**ADDENDA
ADDENDUM No. 1**

Date: March 25, 2019
Project: Oneida Nation Farms – Barn Addition
Project Number: 14-012
Owner: Oneida Nation
Architect: Oneida Engineering Department
N7332 Water Circle Place
Oneida, WI 54155
To: Invited Bidders

This Addendum entails updating the Scope of Work document, Page A-2 of the Design Documents and the Bid Form. This Addendum consist of 5 pages including this sheet and the following attachments:

1 SECTION @ MANURE STORAGE
A-2 3/16" = 1'-0"

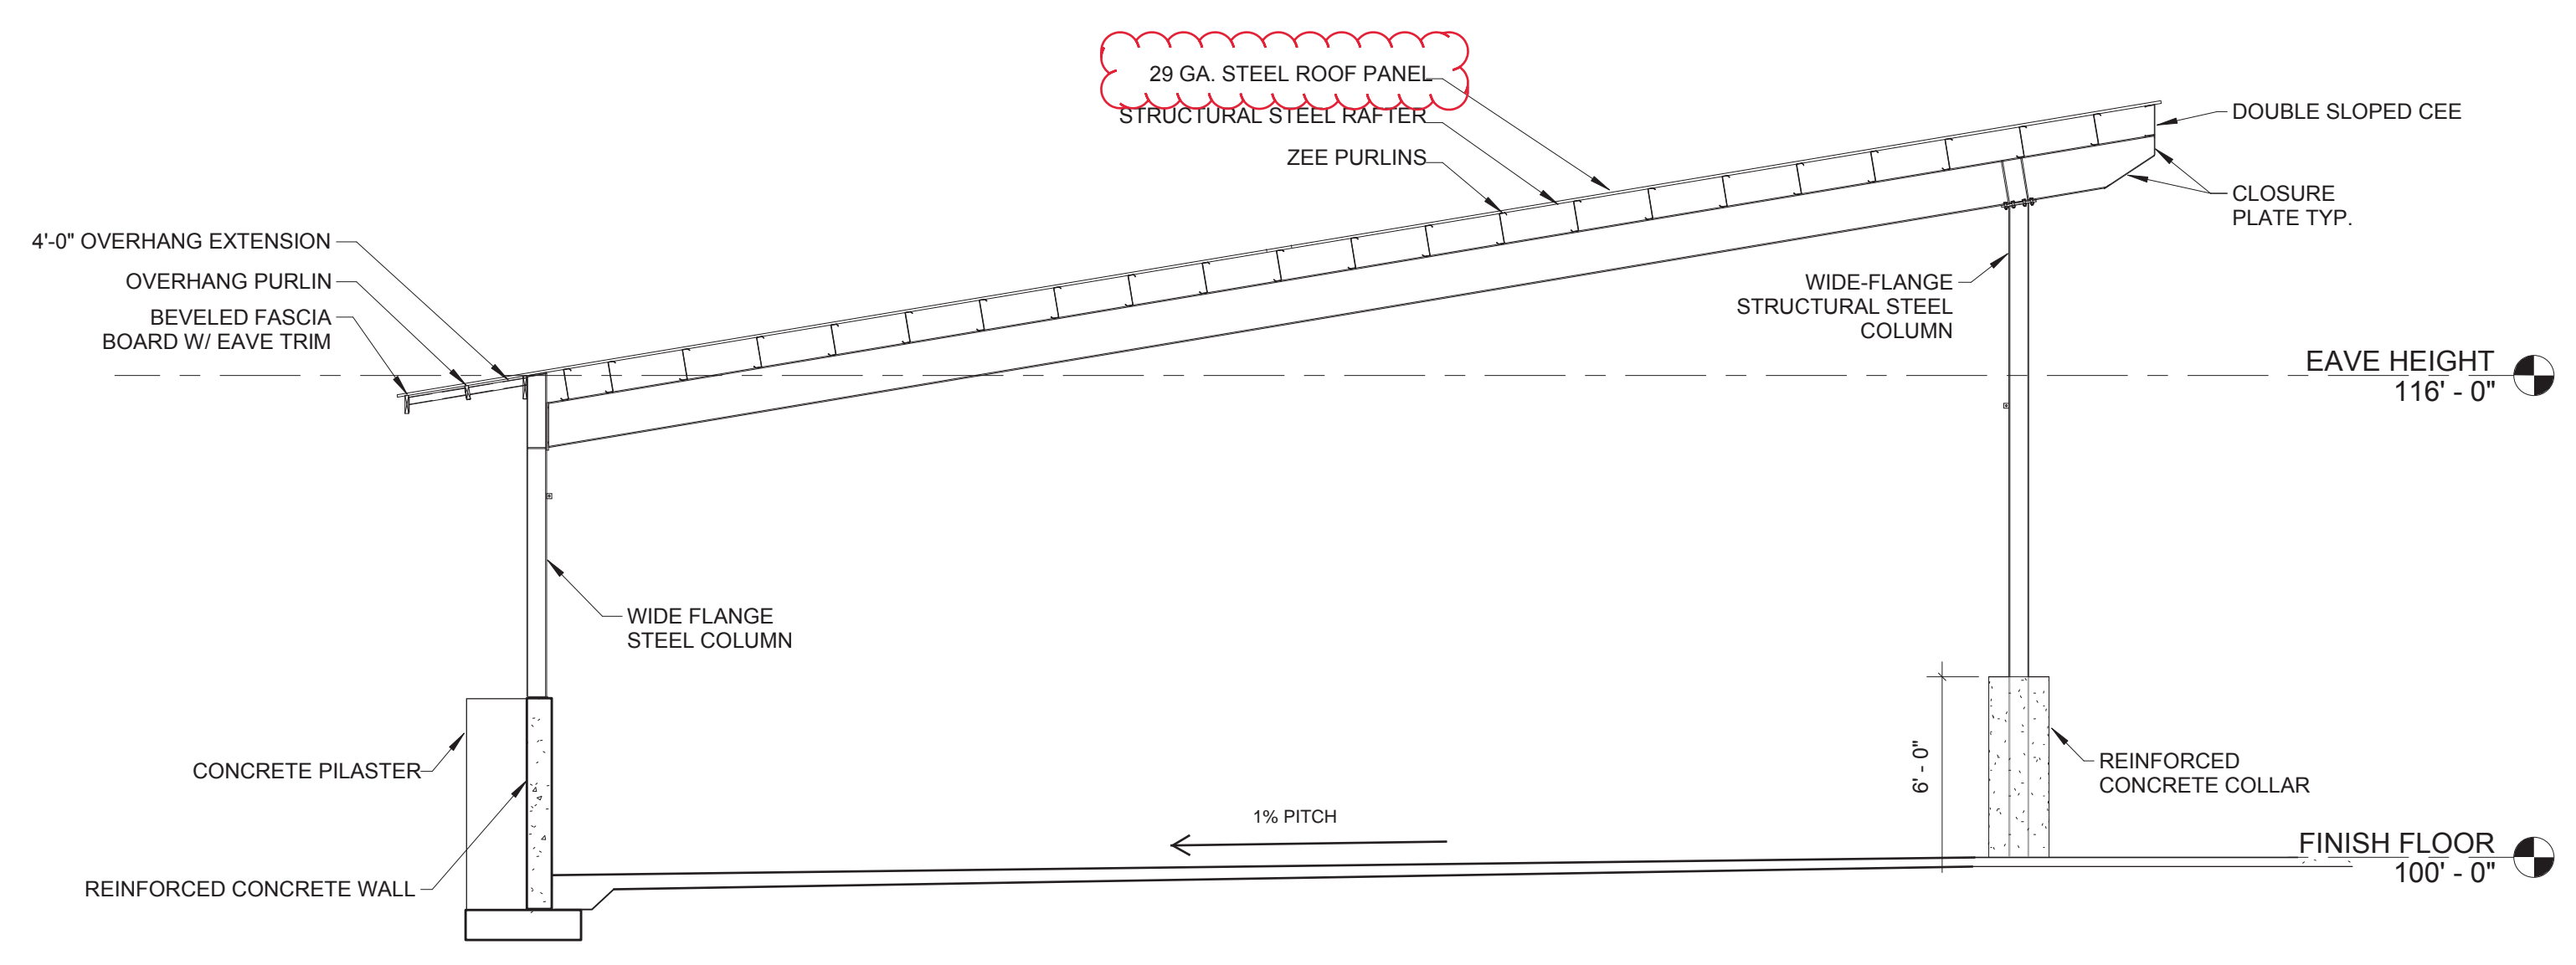
Drawing No.	Plan/Section/Detail	Description of Revision
1.	A-2	1	Revised roof steel to 29 gauge
2.			
3.			
4.

Specification Section	Page No.	Item No.	Description of Revision
1.	Section 9; Division 7- Thermal and Moisture Protection	8	9.2.	Roof Steel for Northeast Waste Storage area to have 29-material. South addition can remain at 26-gauge material.
2.
